Our Ref: P00031_L3_ Response to Transport for NSW.docx
3 March 2021

Ref: CR2020/005288&SF2020/208998

SUBJECT: RESPONSE TO SUBMISSION
PROJECT: MOD TO TINONEE PA (MP 05_0038 MOD 1)

CLIENT	MCGLASHAN AND CRISP SURVEYORS
PROJECT	CARTERS CREEK ROAD INTERSECTION WITH BUCKETTS WAY CARTERS CREEK ROAD, AND KERB RETURN PLAN AND LONGITUDINAL SECTION

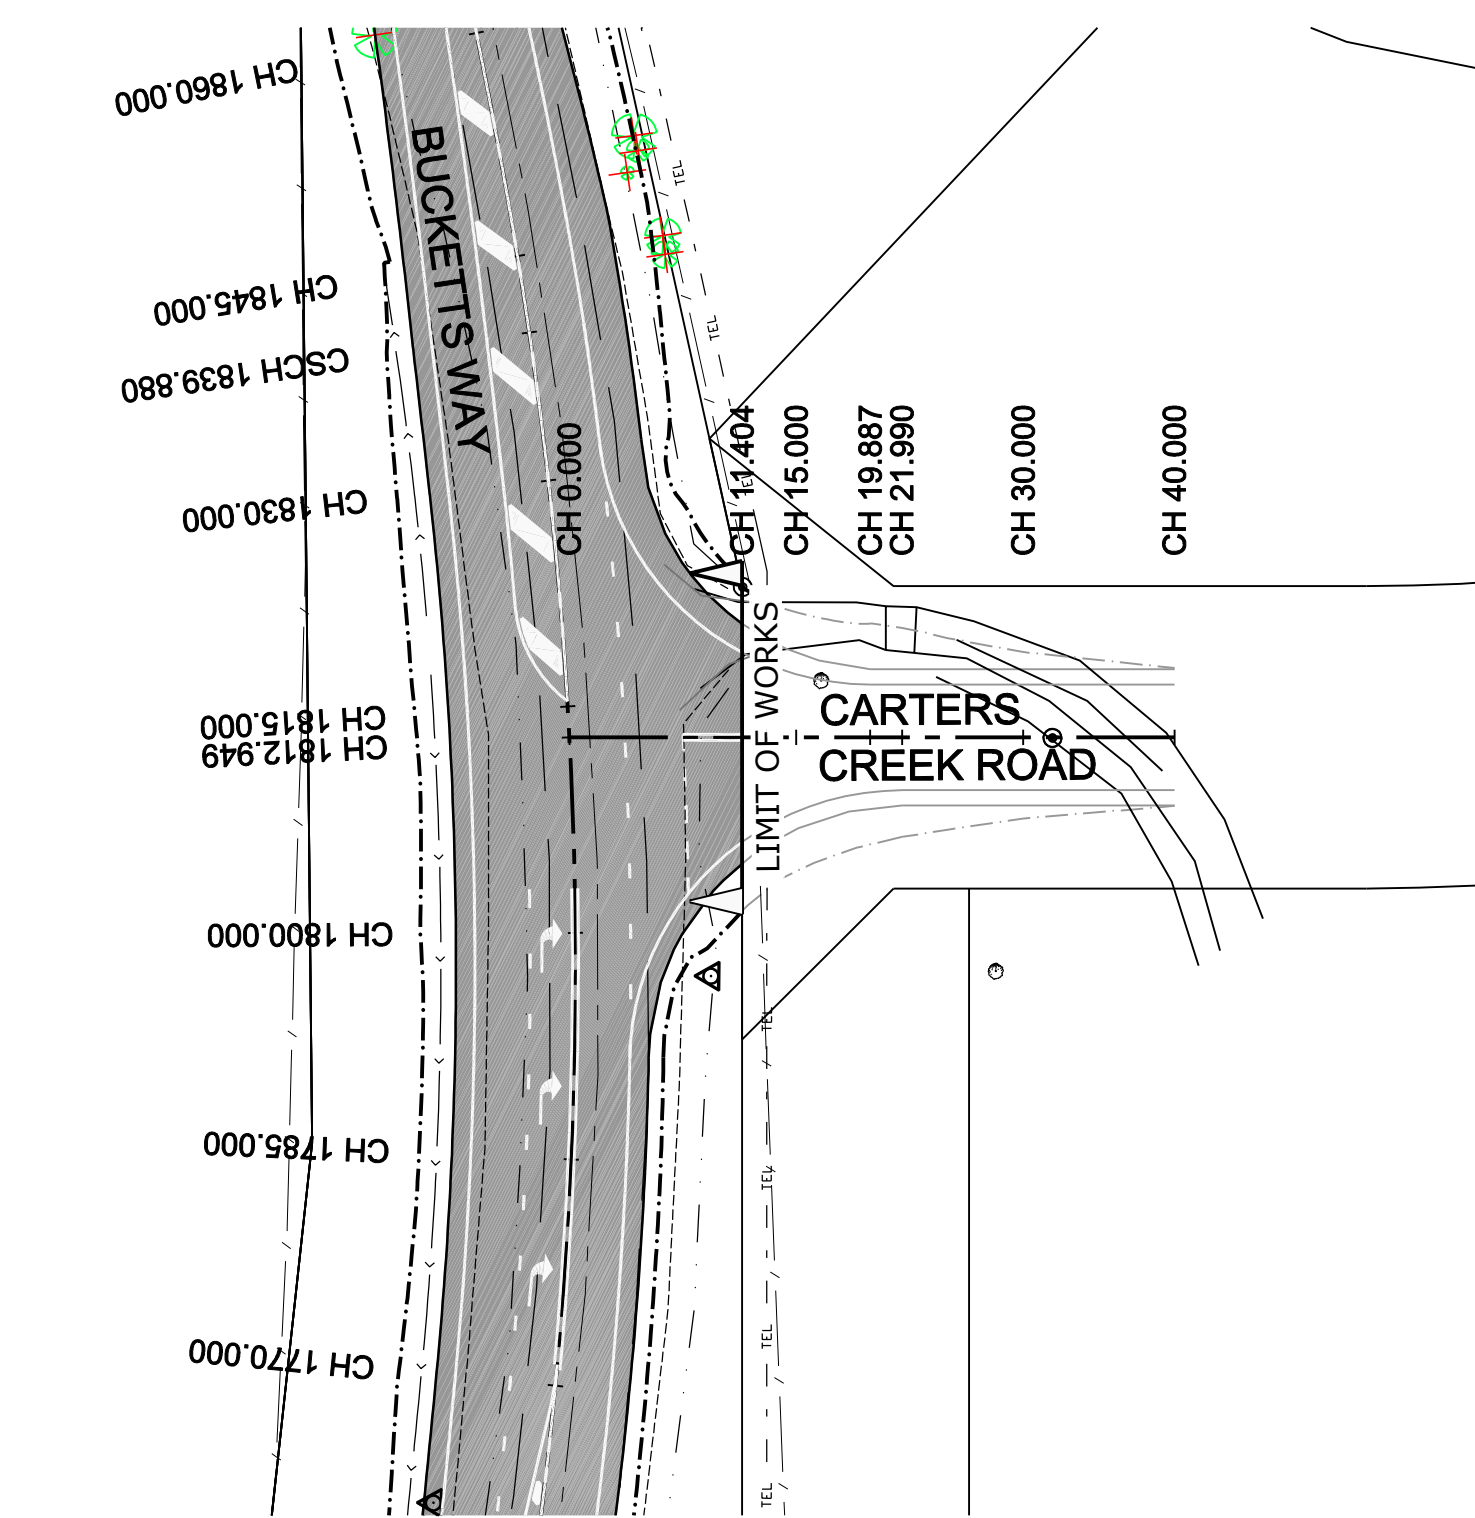
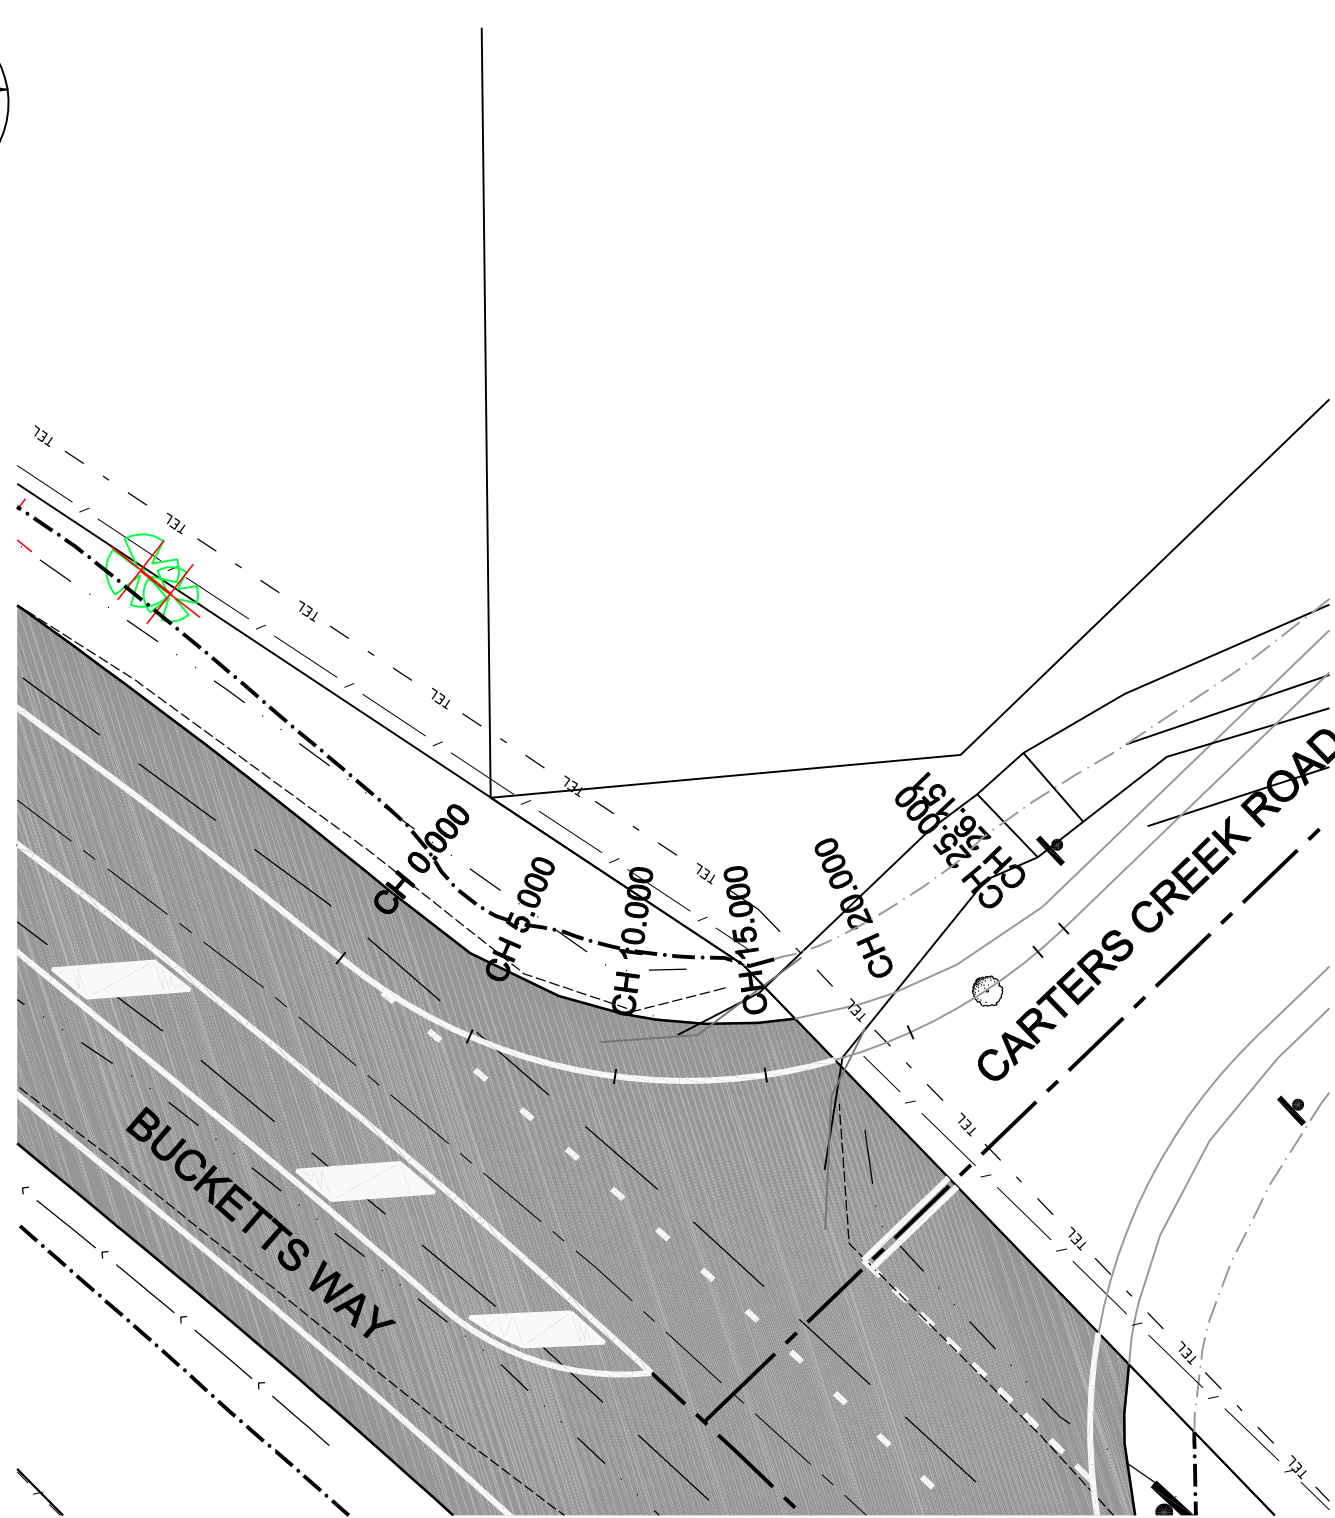
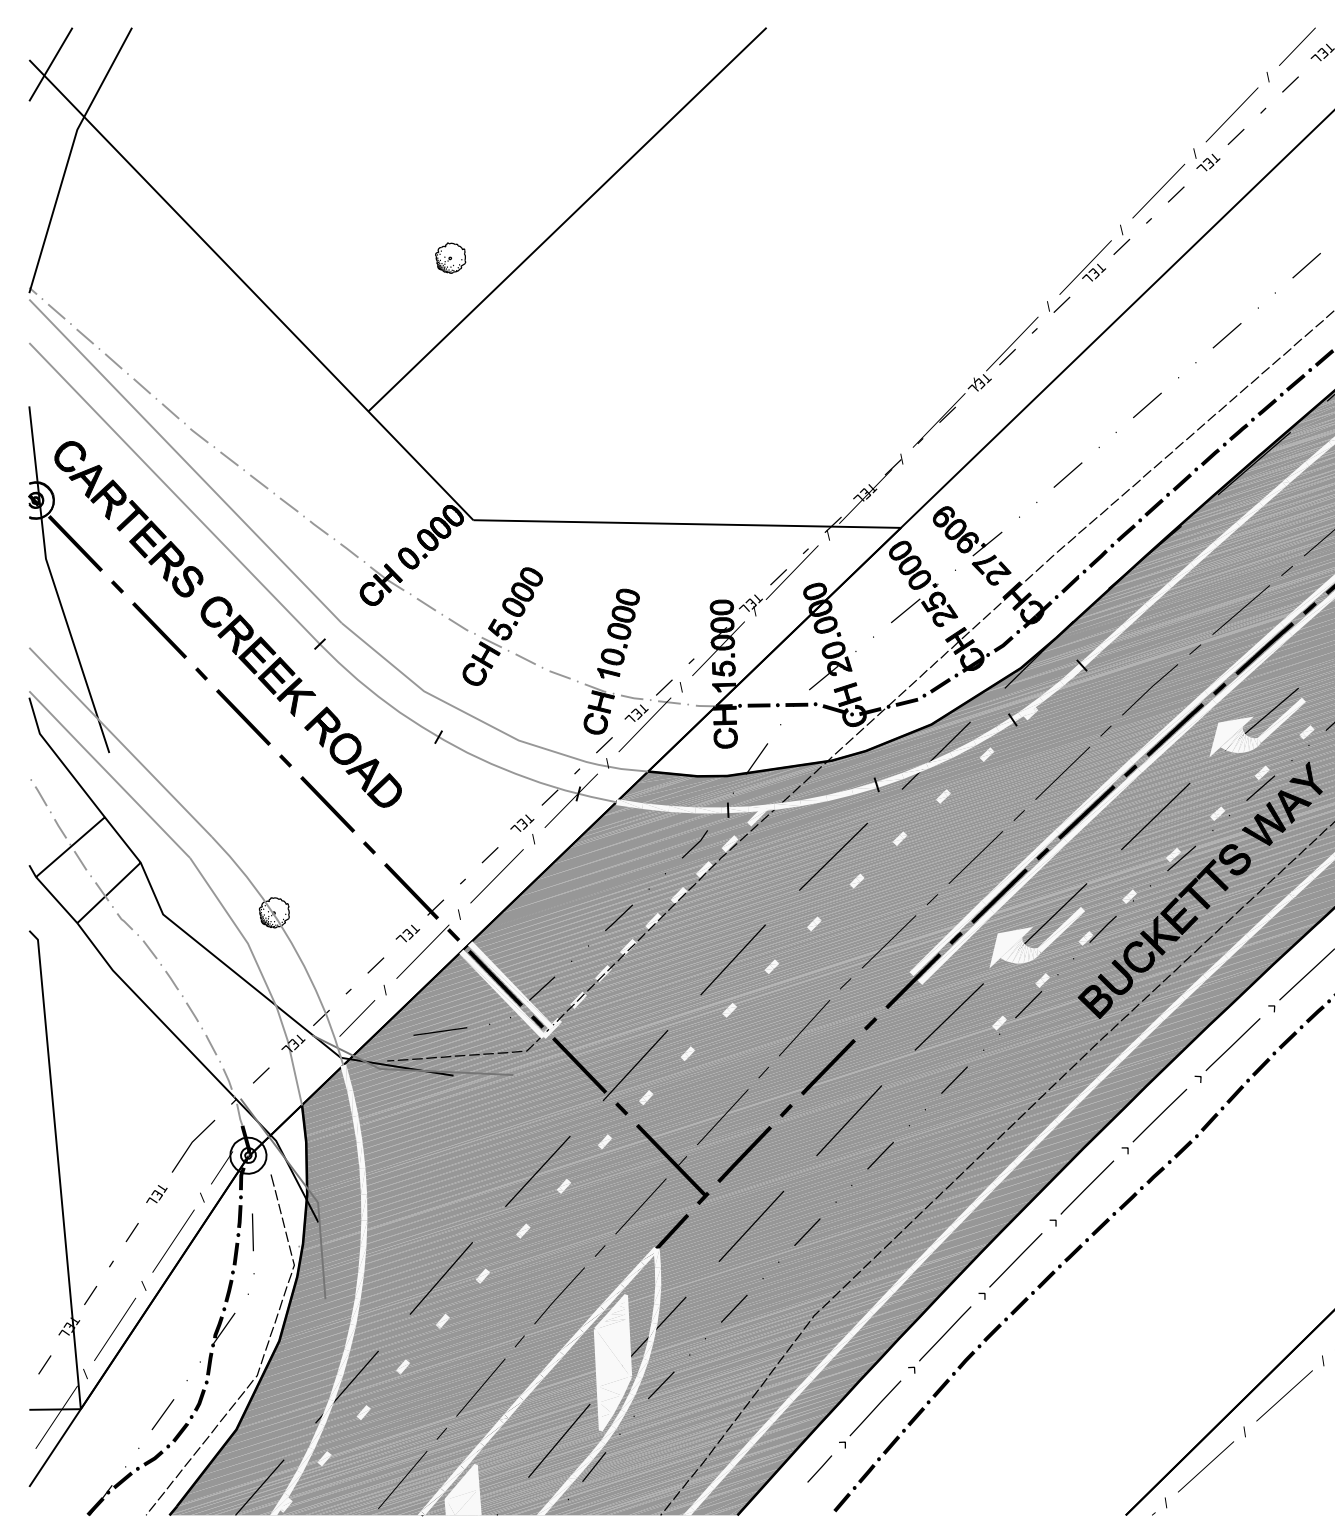
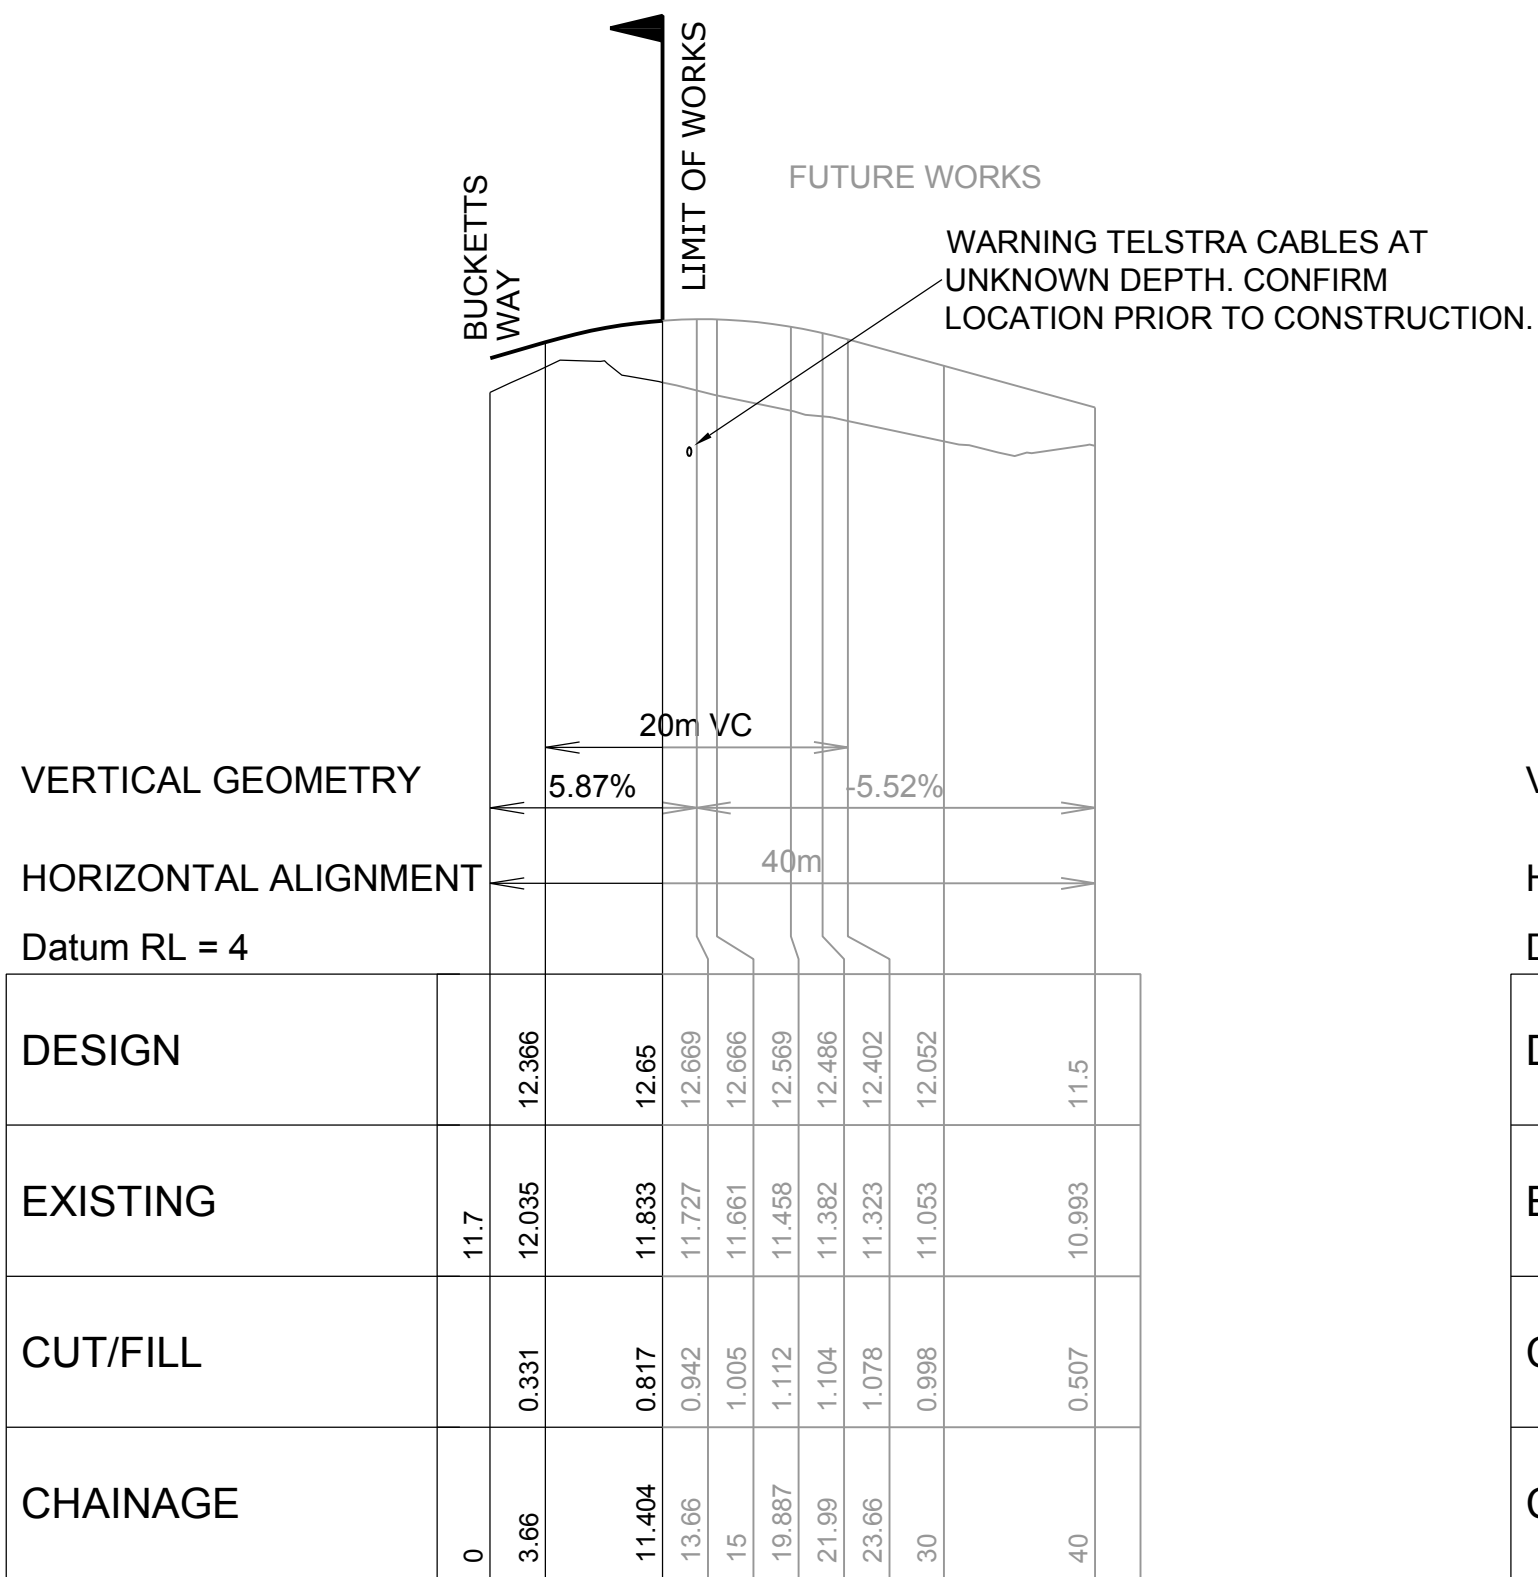
- Adequacy of the proposed intersection treatments with the main subdivision entry and Urray Road.

The main subdivision entry treatment was constructed in October 2015 to a CHR/BAL treatment standard as required by Condition E35 of the Project Approval. Copies of the approved plans for construction are attached.
